STAFF RECOMMENDATION

913 Manila Avenue

Application: New Construction--Infill

Description of Project: This application is for construction of a new single-family, two-story residence.

Figure 1. The vacant lot at 913 Manila Avenue. “Lookaway,” the Italianate historic home at 909 Manila, is to the left.

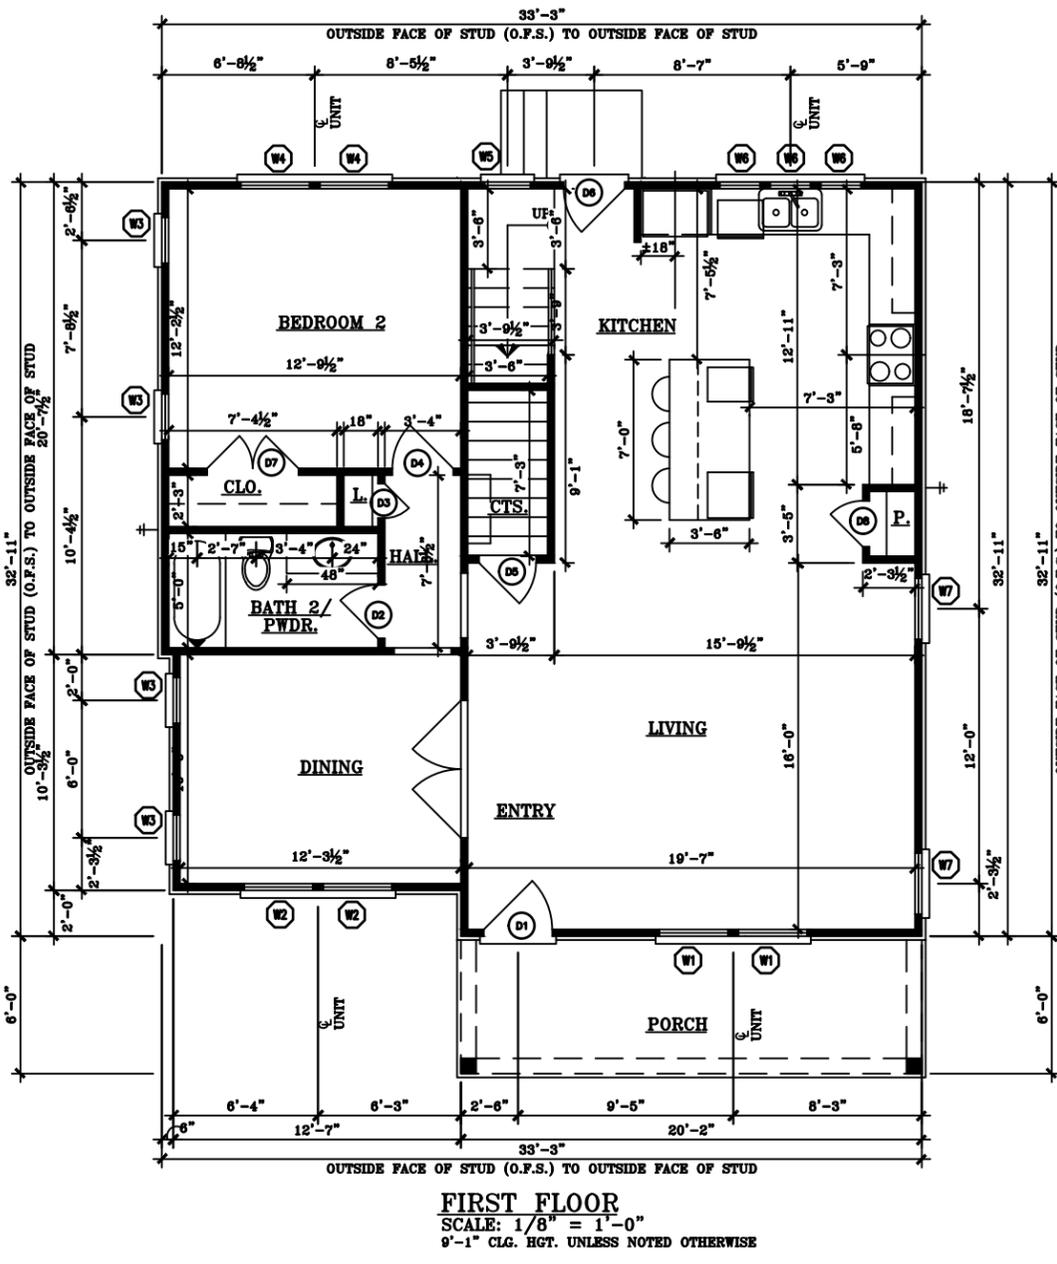
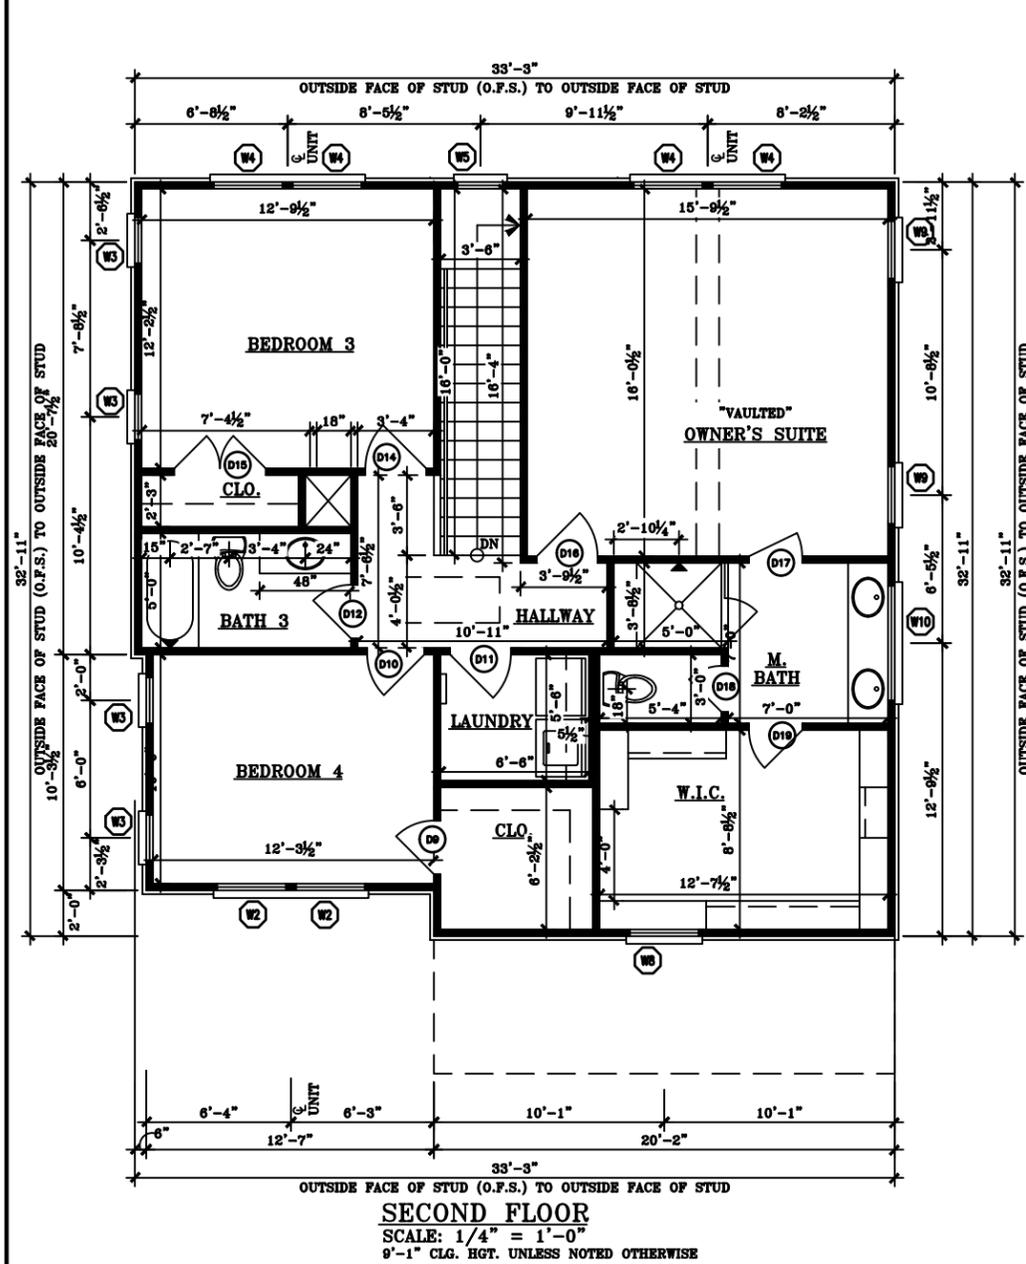
Height & Scale: The proposed new construction is two stories with a height of thirty-two feet, five inches (32' 5") from grade and a width of thirty-three feet, three inches (33' 3"). The nearest contributing building, Lookaway, at 909 Manila (Figure 2) is approximately twenty-four feet (24') tall and the main mass of the building is approximately fifty feet (50') wide. Although the proposed building is taller than the neighboring historic building, staff found it to be appropriate for several reasons. The context is very limited, in this case just one building in the immediate vicinity, as the other homes on Manila Avenue are recent construction or small non-contributing homes. Expanding the area of context, Staff found that there are several two-story contributing homes along Seymour Avenue and Chicamauga Avenue that range in height between twenty-five feet and thirty-five feet (25'-35'). In 2015 the Commission approved infill on Granada and Manila, just behind Lookaway, up to two stories and thirty-three feet (33') tall, and widths up to thirty-six feet (36'). Foundation height is drawn at approximately one foot (1'), and eave height at eighteen feet (18') which is appropriate for a two-story structure. The foundation height is similar to recent new construction approved by the Commission. Elevations should include the grade on the site for accurate assessment of foundation height. Staff recommends the elevations be revised to include the grade. With this condition, Staff finds the two-story design and the overall width and height appropriate. The project meets sections II.B.1.a. and b.

RIGHT SIDE ELEVATION
SCALE: 1/8" = 1'-0"

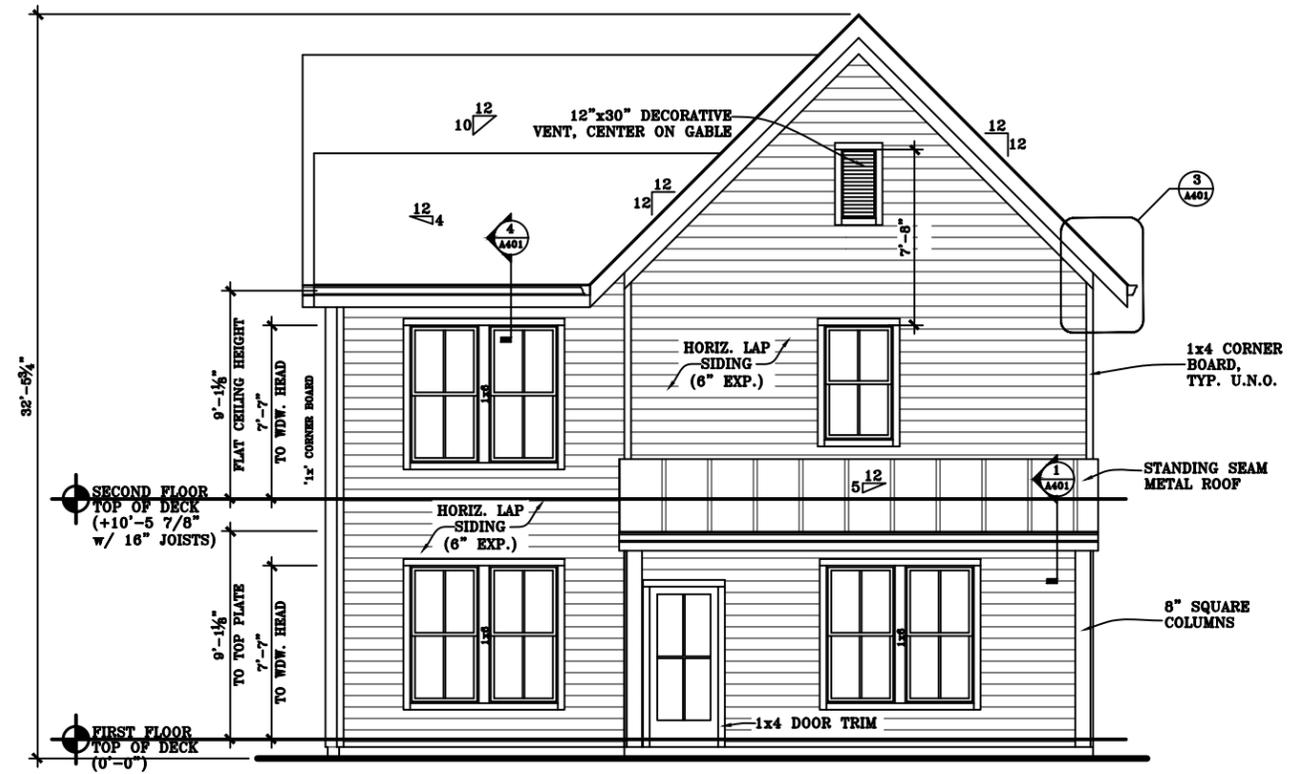
Proportion and Rhythm of Openings: The majority of windows on the front and rear façade are approximately twice as tall as they are wide, meeting the historic proportion of openings. On the sides there are more horizontal and square windows than traditionally proportioned ones. Staff recommends these windows on the left and right sides be re-proportioned to more vertically oriented windows. There is an expanse of sixteen feet (16’) without a window opening on the right side; as this is past the midpoint of the house, and facing the dead end of the street, staff finds that the visibility of the

fenestration in this location will be minimal. With the condition that the square and horizontal windows on the side facades are redesigned to be a more traditionally proportioned window or windows. With these conditions, the project will meet Section II.B.1.g.

1. Parking is moved to the rear yard, and a front walkway is added to address the street, with revised site plan submitted prior to permitting;
2. Elevations are revised to show grade;
3. Window openings on the side facades are enlarged to a more vertically proportioned design;
4. The finished floor height shall be consistent with the finished floor height of the neighboring historic home;
5. Administrative review of roofing color, windows, and doors;
6. Lap siding shall be smooth-faced and have maximum five inch (5”) reveal; and,
7. HVAC and other utilities will be located at the rear, or beyond the midpoint on a side façade.

PRELIMINARY PLOT PLAN

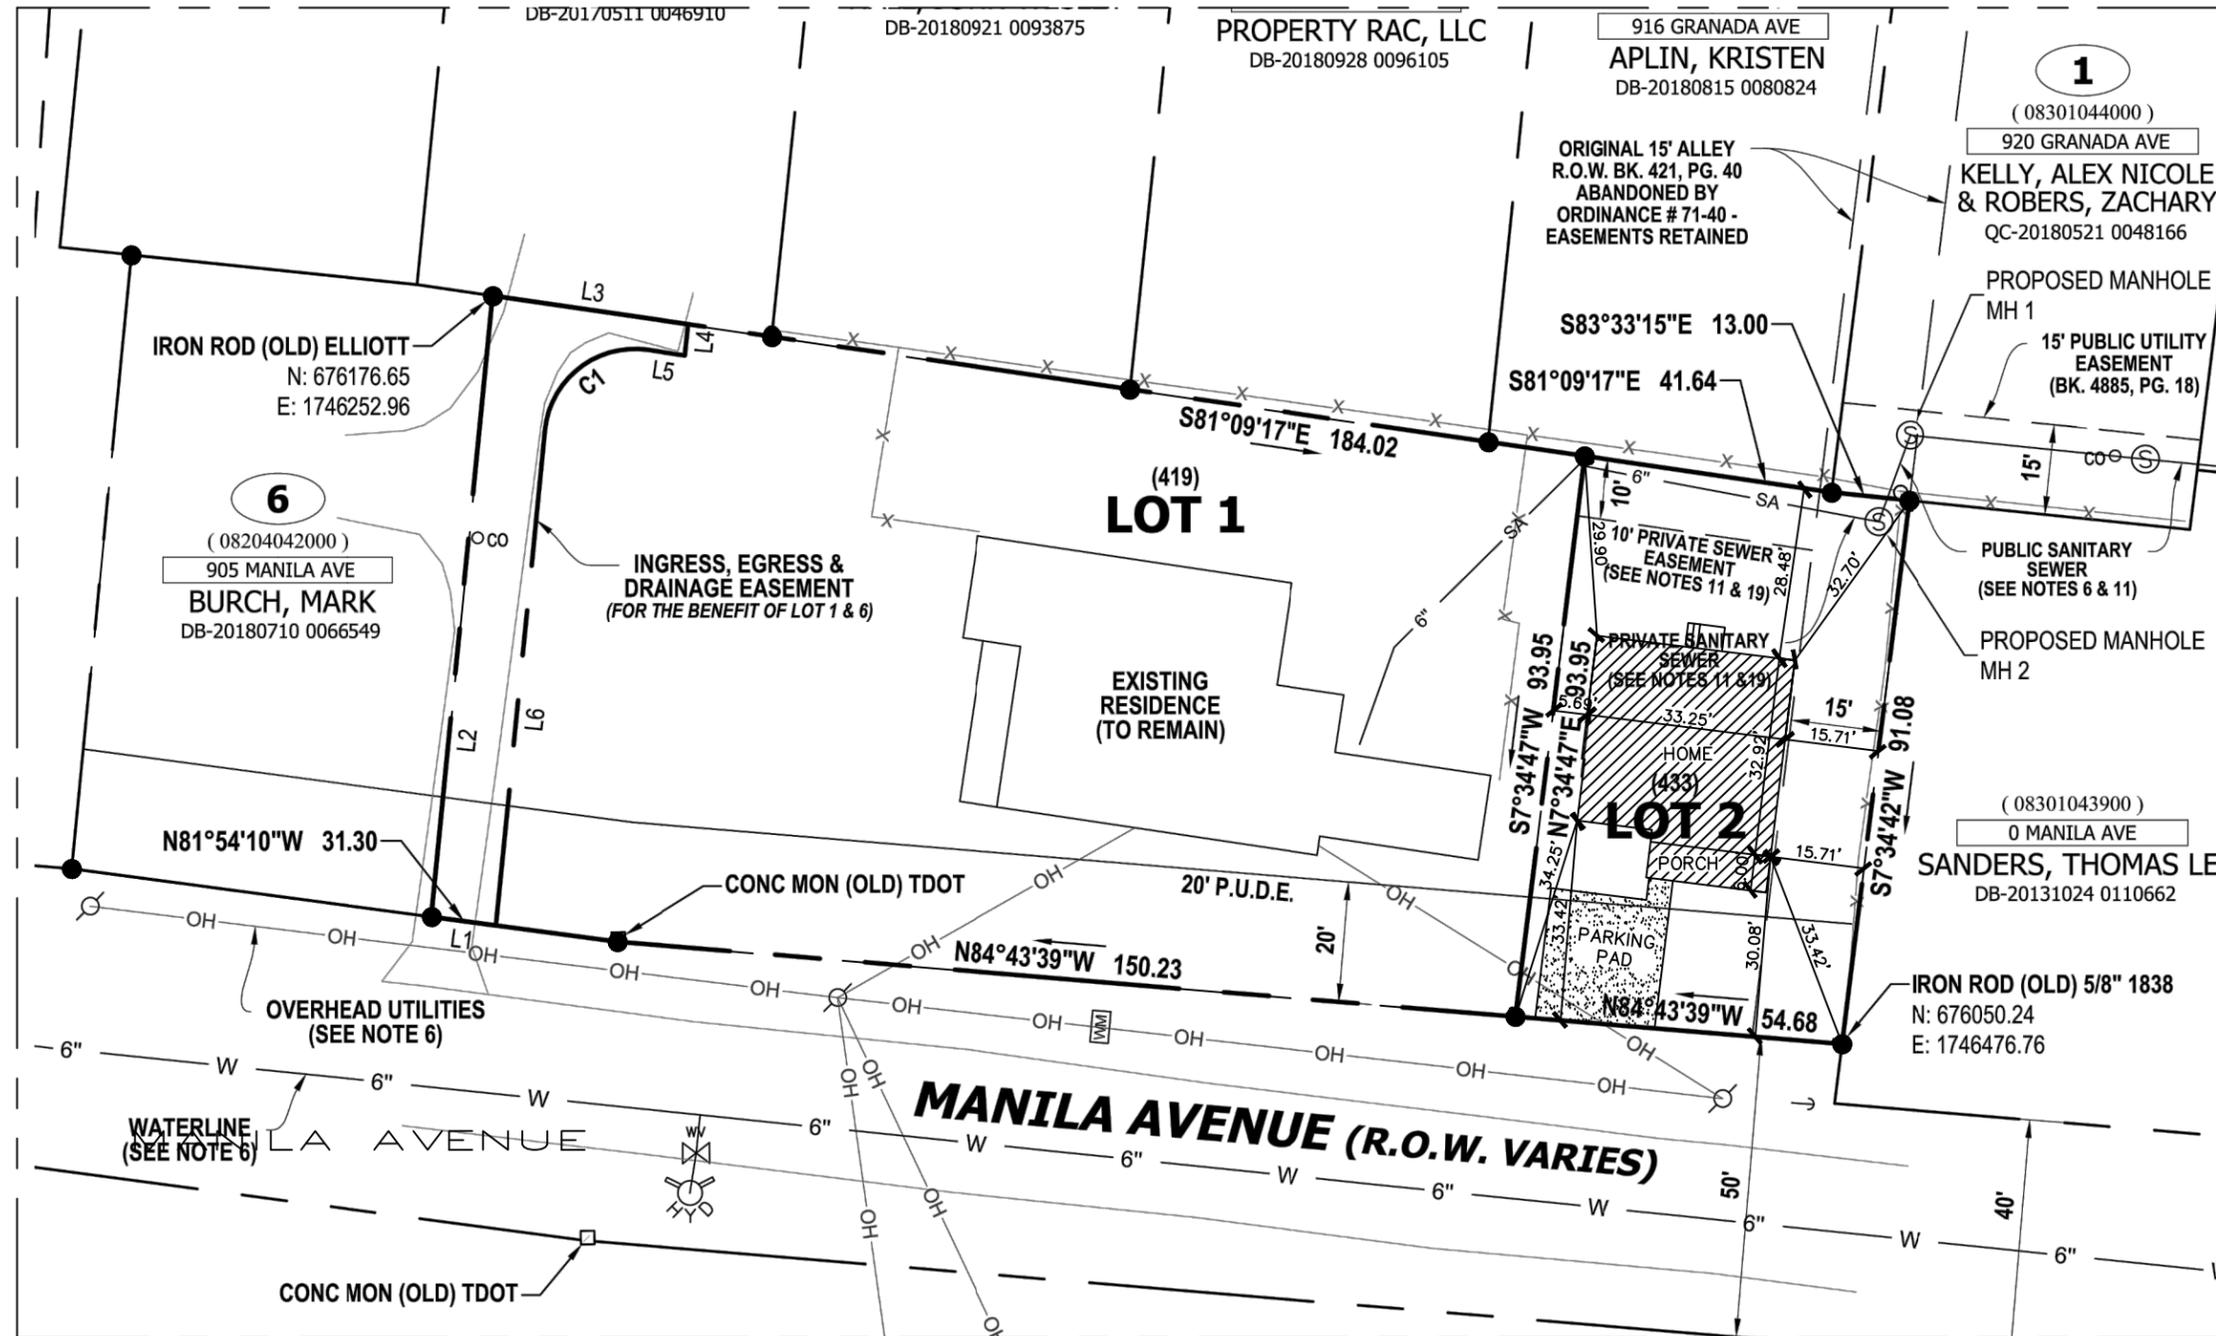
Setback & Rhythm of Spacing: The left side setback is five feet, eight inches (5' 8") and the right-side setback is fifteen feet, nine inches (15' 9"). The side setbacks meet the base zoning requirements of five feet (5') on each side. Staff found the side setbacks to be appropriate as they allow for a side driveway. The front setback is approximately thirty feet (30'), compared to the approximate twenty-five feet (25') of the historic home adjacent to it. The rear setback is more than twenty-eight feet (28') which meets the required minimum of twenty feet (20'). The project meets section II.B.1.c.

Orientation: The proposed building is oriented to the street with a front entrance facing the street and a six foot (6’) deep, partial-width porch. Vehicular access is a parking pad in the front yard. The Commission has not approved front-yard parking when there are other options. Staff recommends the parking be moved behind the house. If necessary, the front setback could be reduced to twenty-five feet (25’) matching the side setback of the historic home adjacent to it. With the condition that the project not include front-yard parking the project meets section II.B.1.f.
